SECTION: 303-03 (26 - Cooling System)

Discovery II - Method Change - Viscous Fan Renew

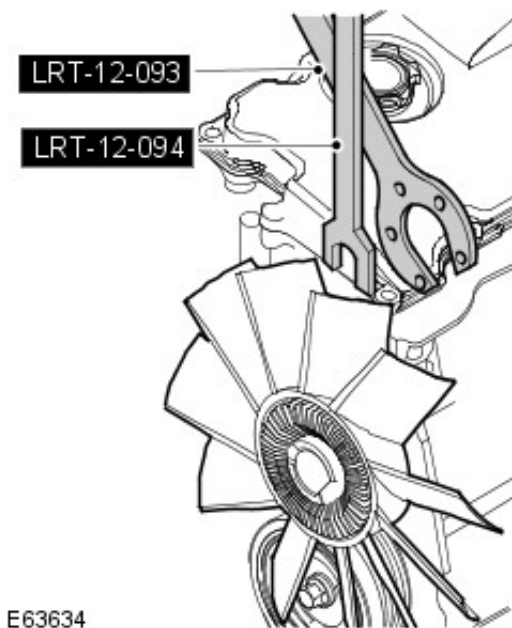
Situation: Change to Methods for removal and installation of the viscous fan assembly.

Methods engineers at Land Rover have recently studied the service process for renewal of the viscous fan assembly for Discovery II Td5 models, and significant process changes have been made. The changes, detailed below, refine and improve the process which allow the operation to be carried out more efficiently.

- Step for removal of acoustic cover - deleted.

- 1 Remove the upper fan cowl.
- 2 Remove the viscous fan coupling unit, using tools LRT-12-093 and LRT-12-094.

- 3 Position the viscous fan coupling unit and tighten using tools LRT-12-093 and LRT-12-094.
- 4 Install the upper fan cowl.
